Project: Castleberry ISD High School Addition
Project No: 2359

September 19, 2024
Addendum No. 1

The following items modify the drawings and specifications and shall become a part of the contract documents.

S201.2

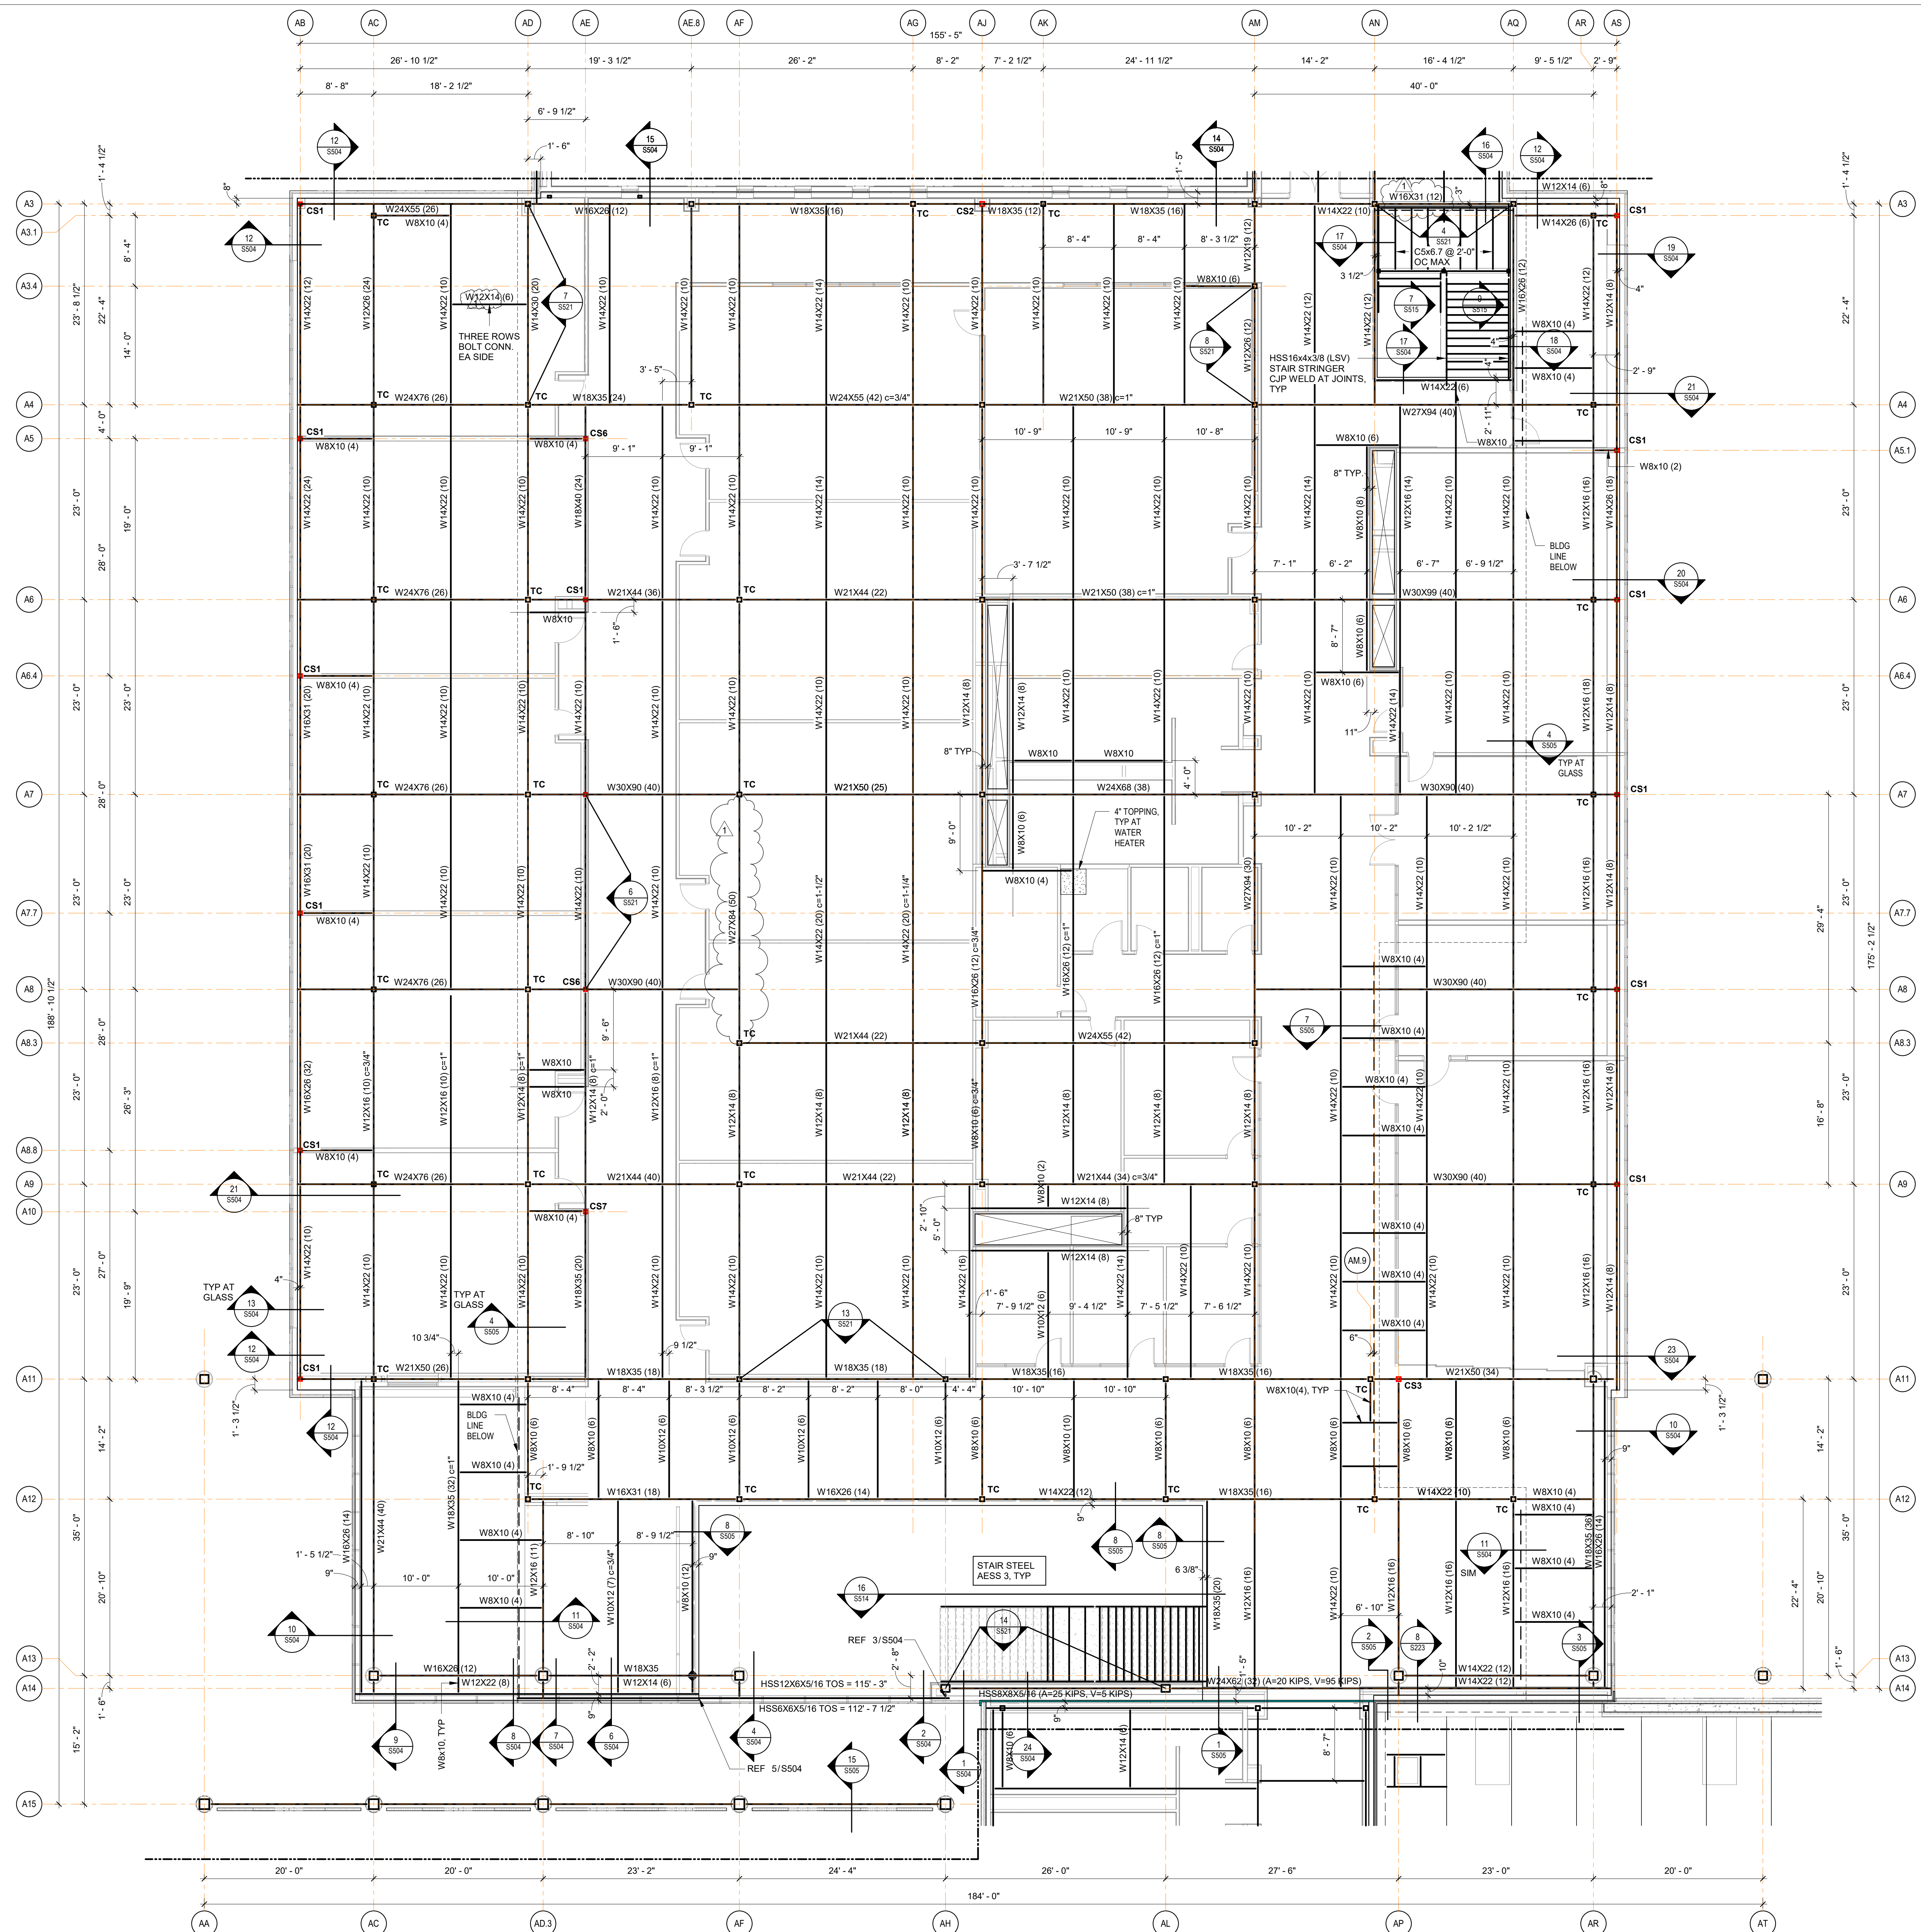
B. *DETAIL 1: UPDATED COL ORIENTATION ON PLAN*

15 ROOF FRAMING PLAN - UNIT B STORM SHELTER
SCALE : 1/8" = 1'-0"

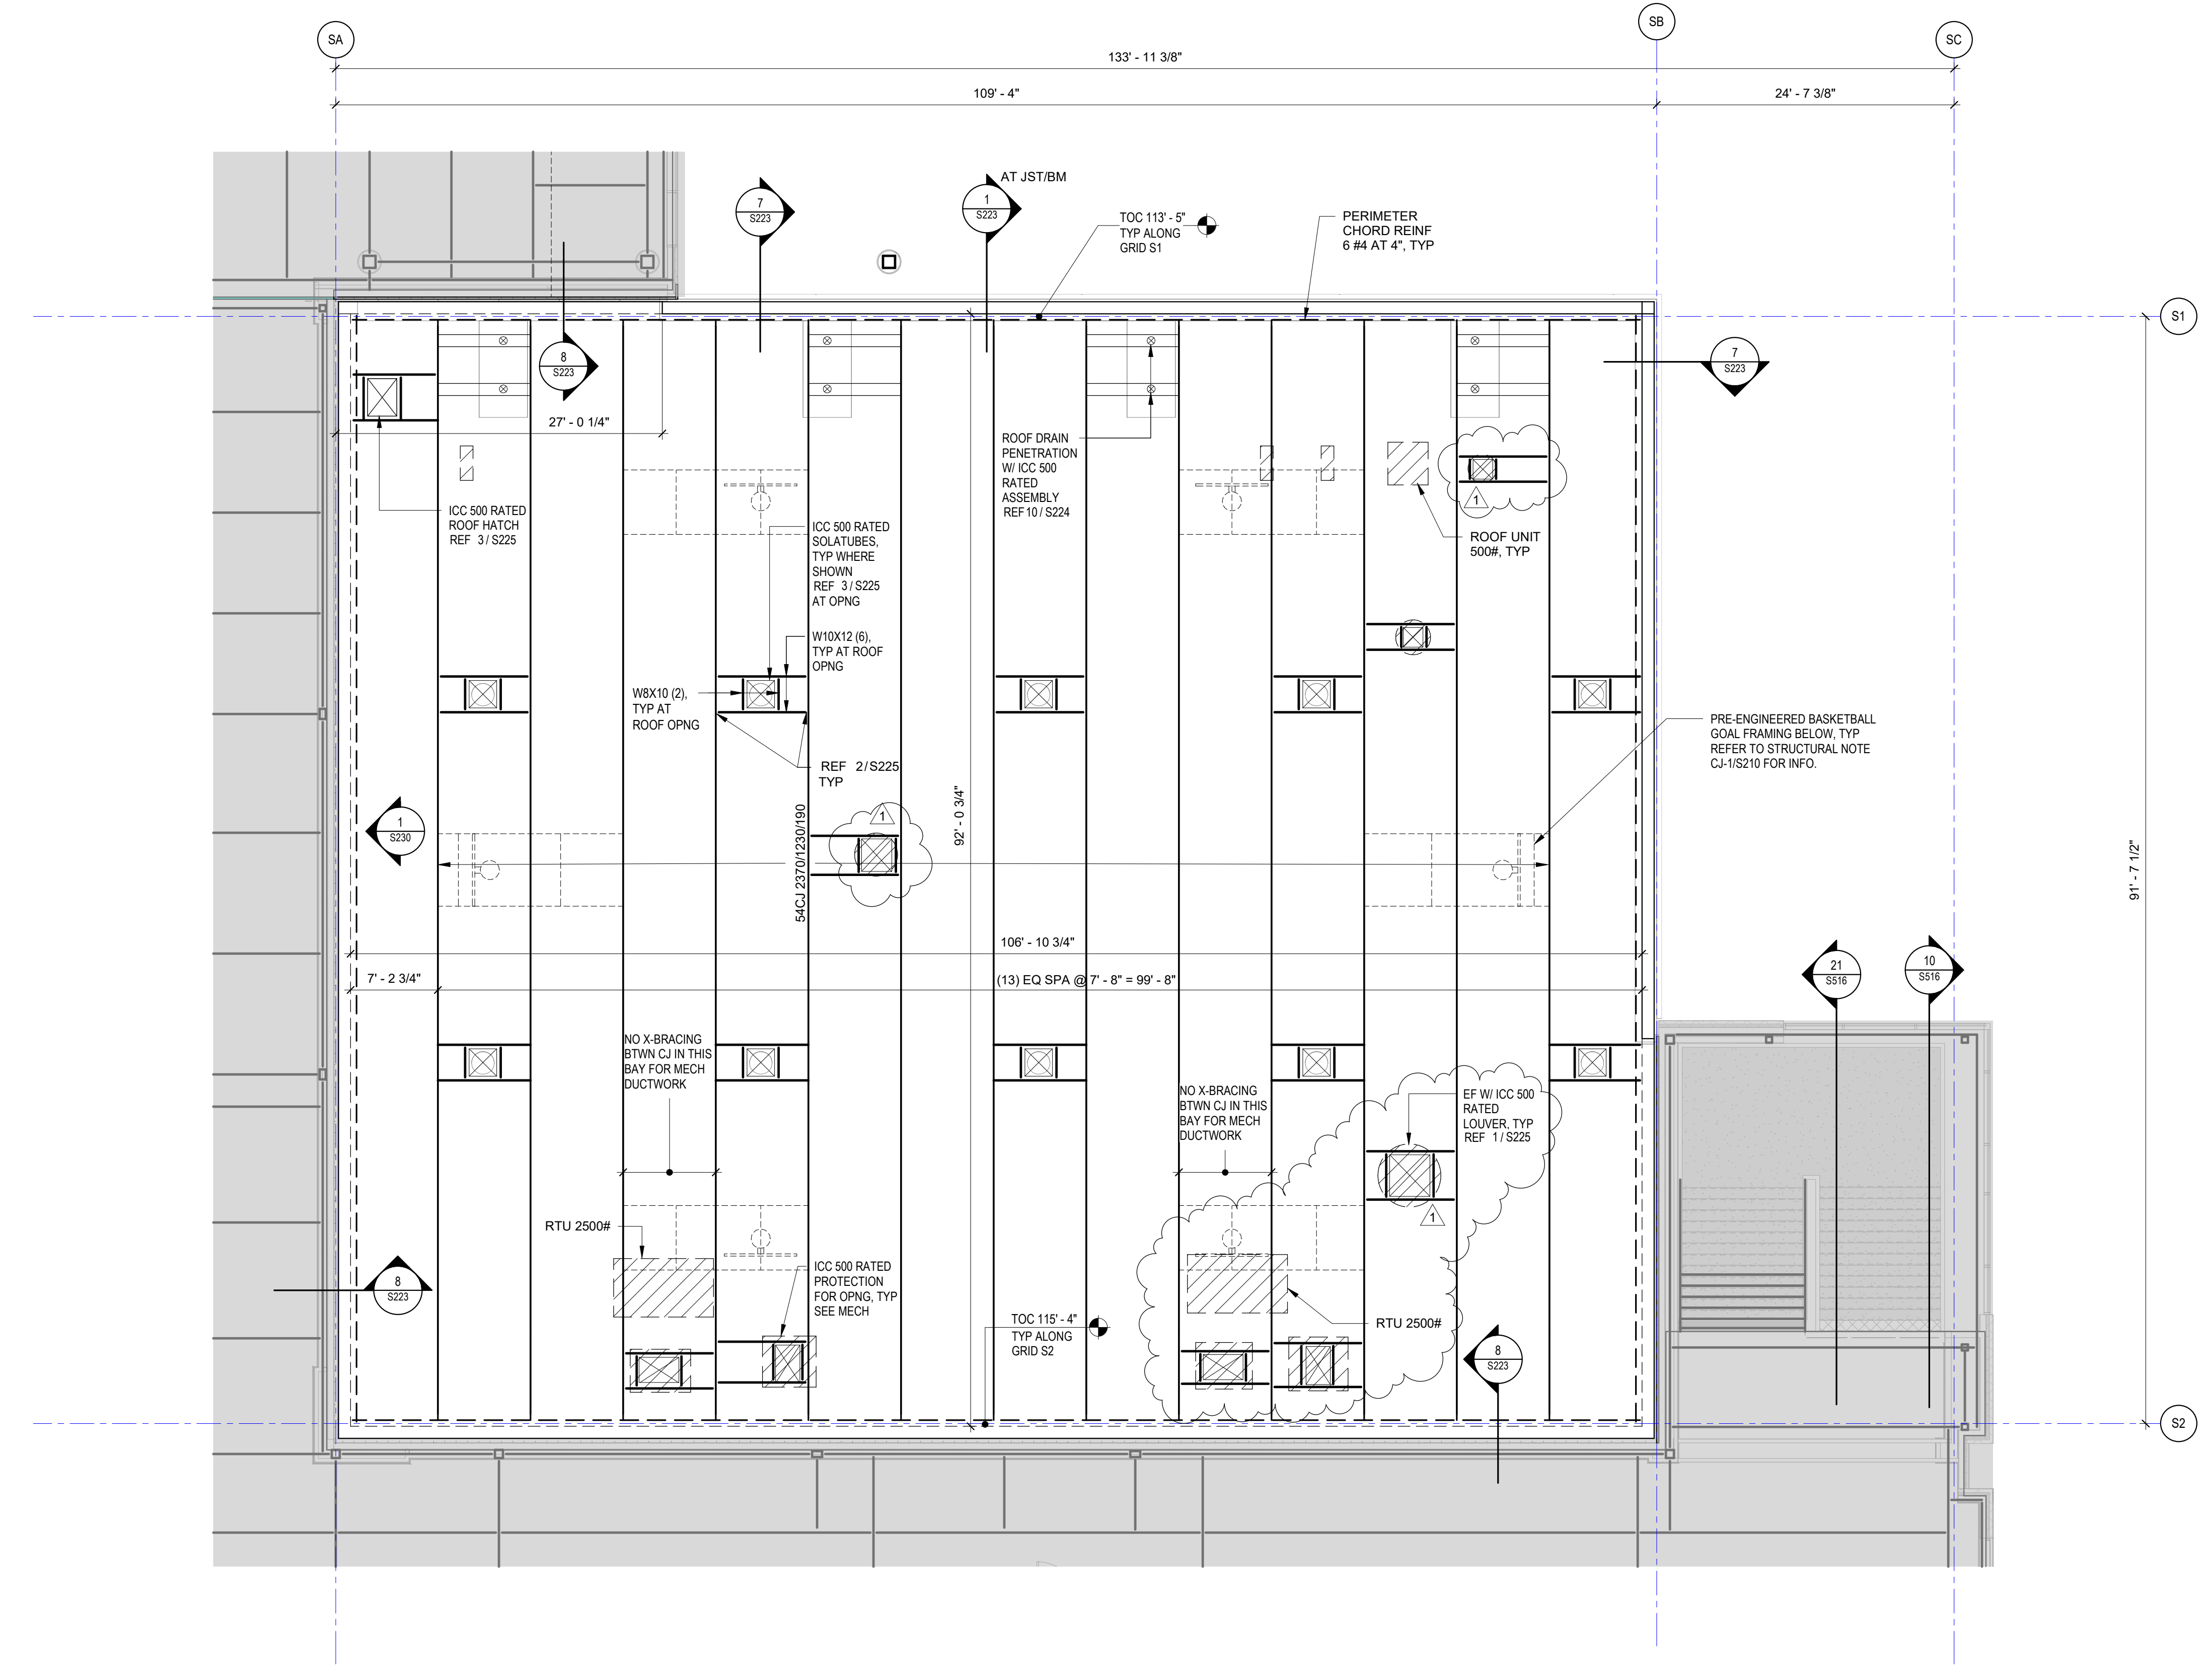
- A. *DETAIL 15: UPDATE ROOF UNITS*

1 Floor Plan - Level 2 Unit A.1
1/8" = 1'-0"

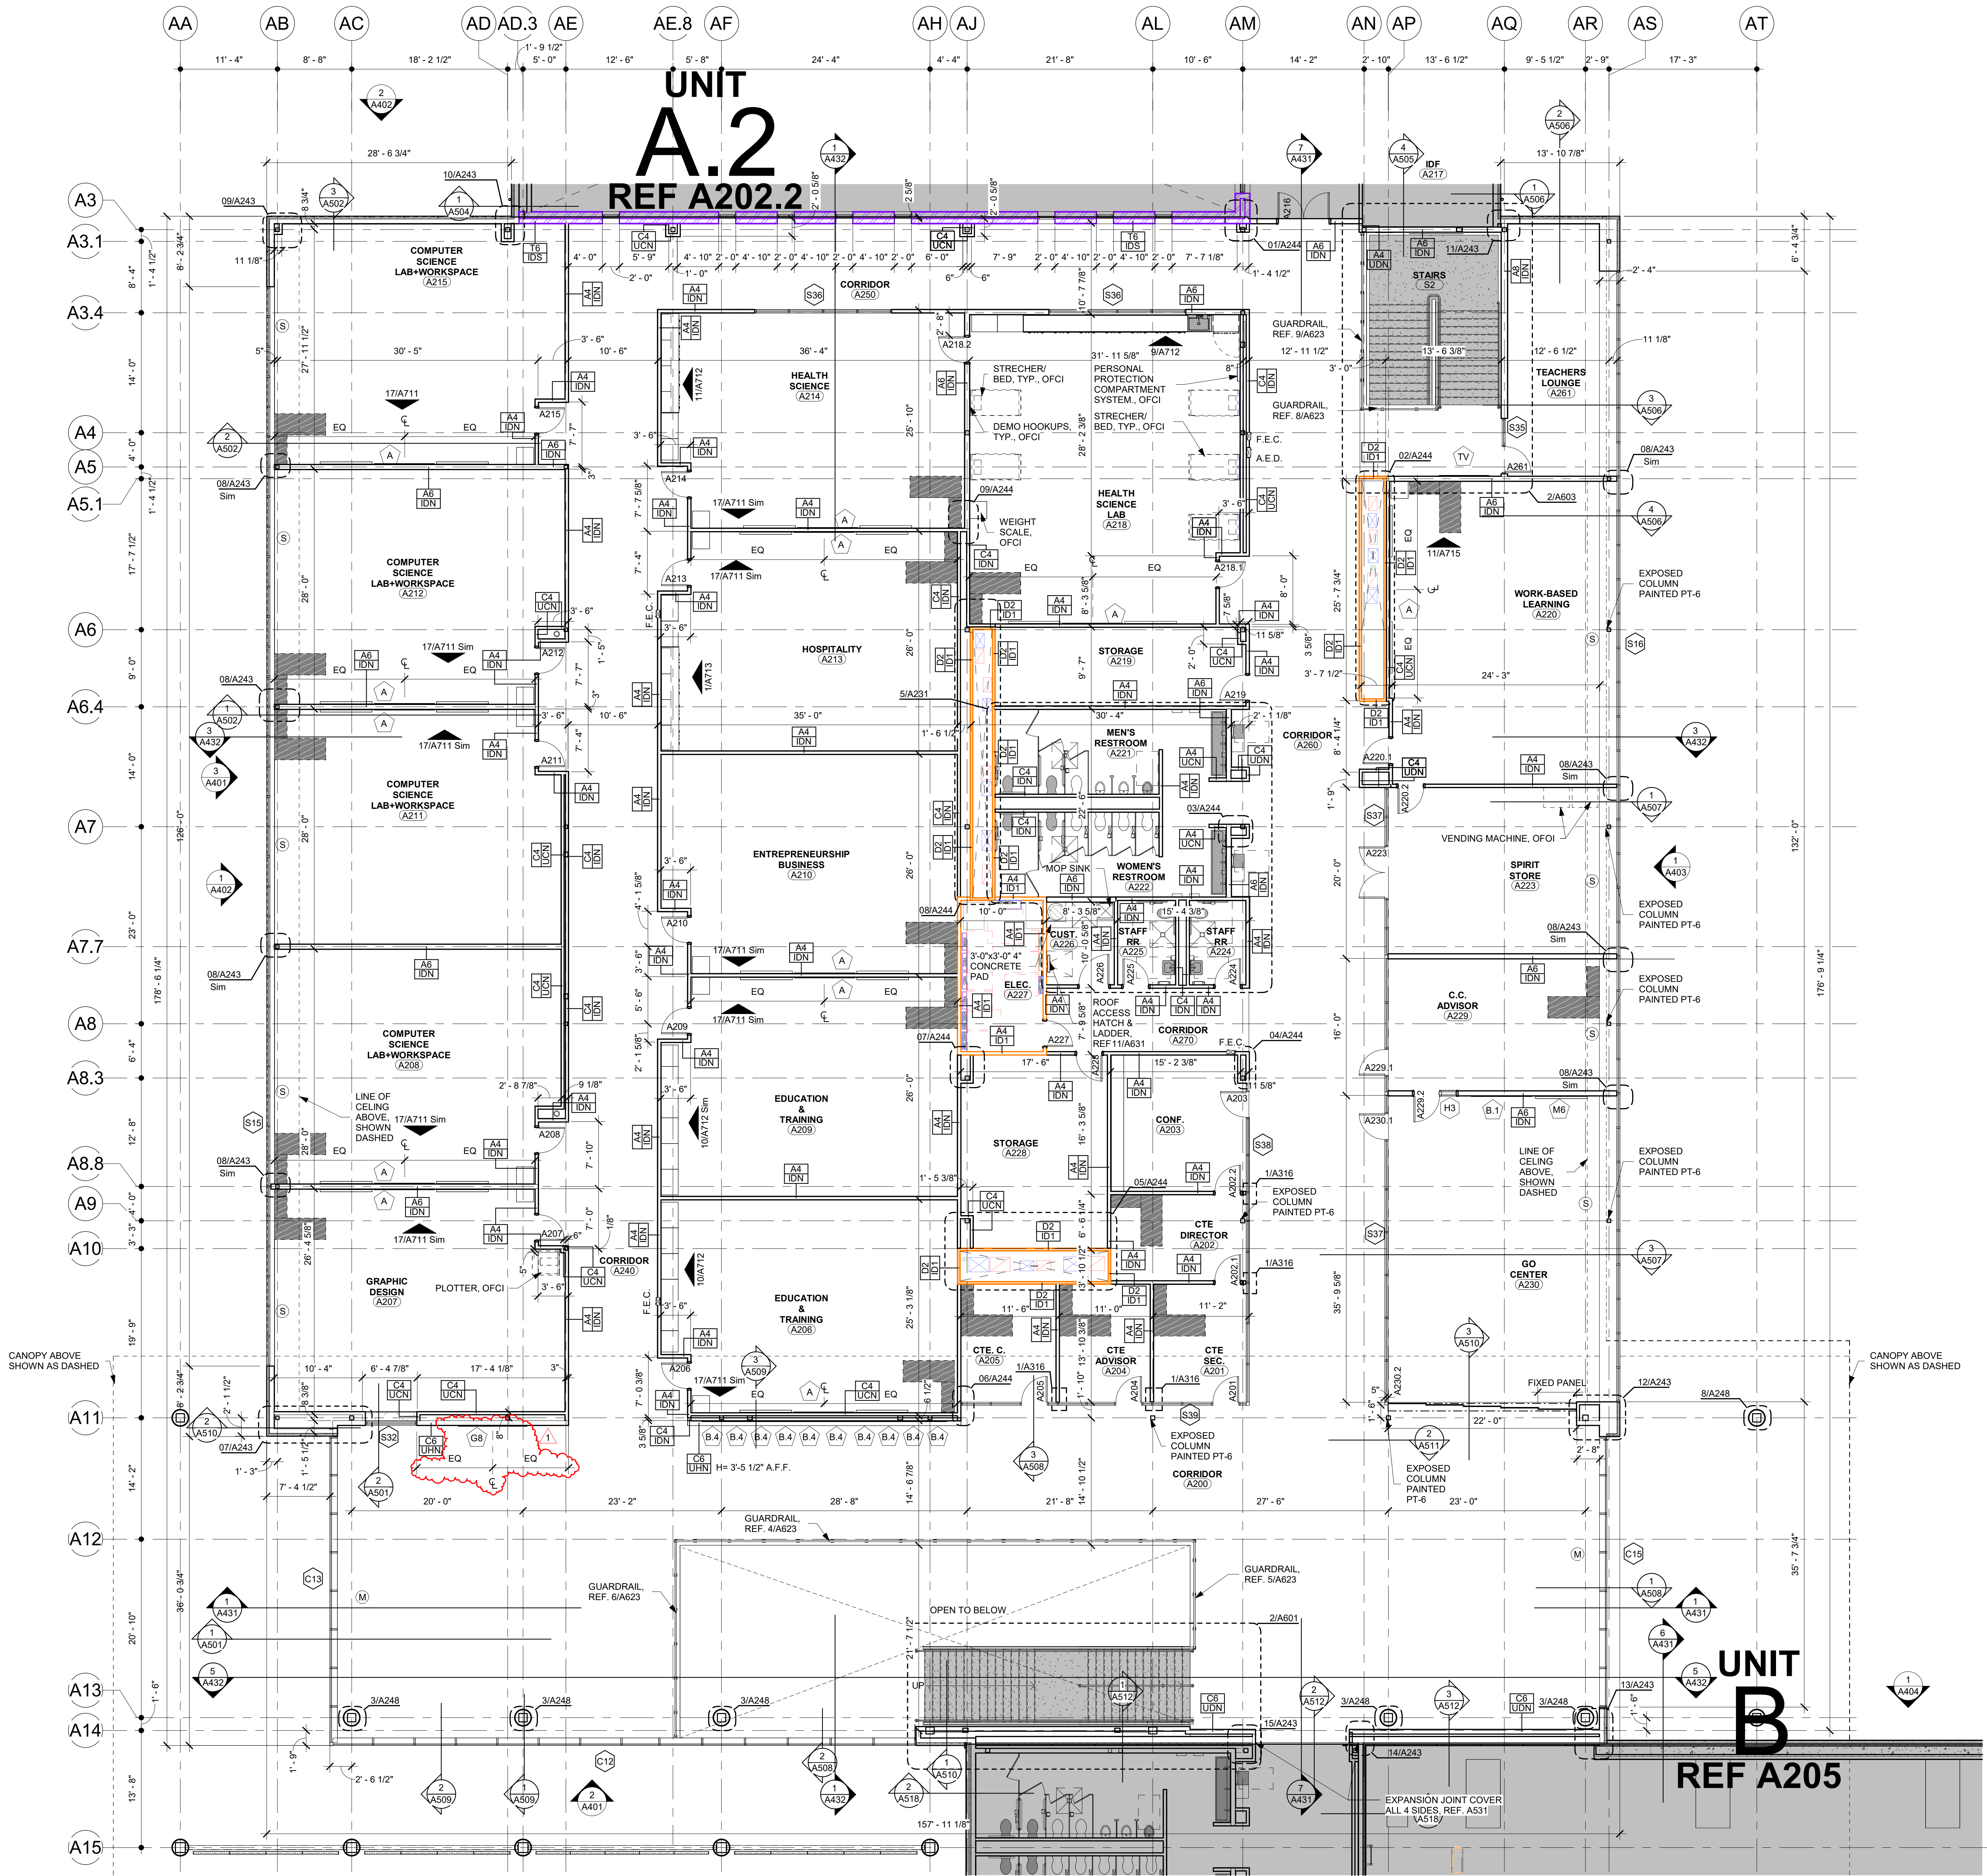
ITEM NO. 57. DRAWING SHEET – A202.1 – FLOOR PLAN LEVEL 2 UNIT A.1
